Access Compliance Report

(Curb Ramps)

Intersection ID: 20860	Main Street: CROWNPOINT_EXECUTIVE_DR	Cross Street: KREFELD_DR	Location:	NE
ADA ID: C4A328A9D5DB	Ramp Type: Perp	Initial Pass/Fail: Fail	Overall Compliance: No	Severity Score: 37.5
Codes/Mitigation Info/Possible Solution		Field Measurements/Component Compliance

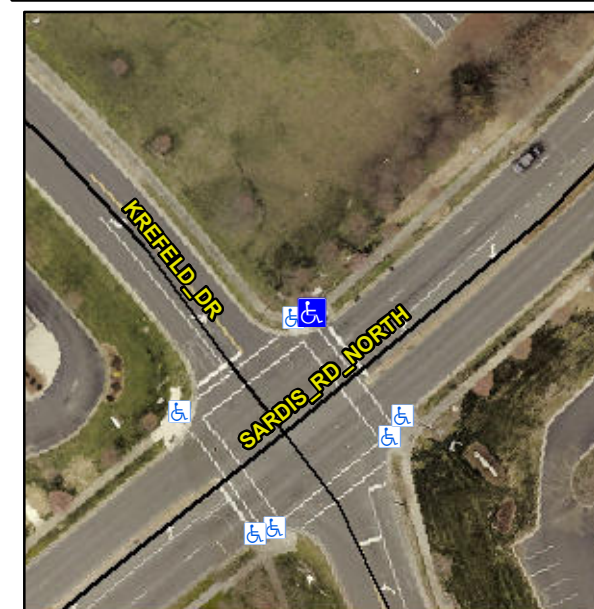
Not Found, R304.2.2, R304.5.3

Compliance	Description	Data	Compliance	Description	Data
N/A	Ramp Length (in)	61.0	No	Ramp Slope (%)	9.3
Yes	Ramp Width (in)	48.0	No	Ramp XSlope (%)	7.9
N/A	Flare Type LT	N/A	N/A	Flare Type RT	N/A
N/A	Flare Slope LT (%)	N/A	N/A	Flare Slope RT (%)	N/A
N/A	Flare Traversable LT?	N/A	N/A	Flare Traversable RT?	N/A
N/A	Landing Length (in)	N/A	N/A	DWS Provided?	N/A
N/A	Landing Width (in)	N/A	N/A	DWS Contrast?	N/A
N/A	Landing Slope (%)	N/A	N/A	DWS Length (in)	N/A
N/A	Landing X Slope (%)	N/A	N/A	DWS Full Width?	N/A
N/A	Landing Curb? (Y/N)	N/A	N/A	DWS Offset (in)	N/A
N/A	Shared Landing?	N/A			
N/A	Gutter Ponding?	N/A	N/A	Gutter Slope (%)	N/A
N/A	Gutter Lip Ht (in)	N/A	N/A	Gutter X Slope (%)	N/A
N/A	Painted X Walk1?	No	N/A	Painted X Walk2?	N/A
	X Walk 1 Direction	To SE		X Walk 2 Direction	N/A
N/A	X Walk 1 Width (in)	N/A	N/A	X Walk 2 Width (in)	N/A
	X Walk 1 Slope (%)	5.6		X Walk 2 Slope (%)	N/A
	X Walk 1 X Slope (%)	3.1		X Walk 2 X Slope (%)	N/A

Remove & Replace Entire Ramp.
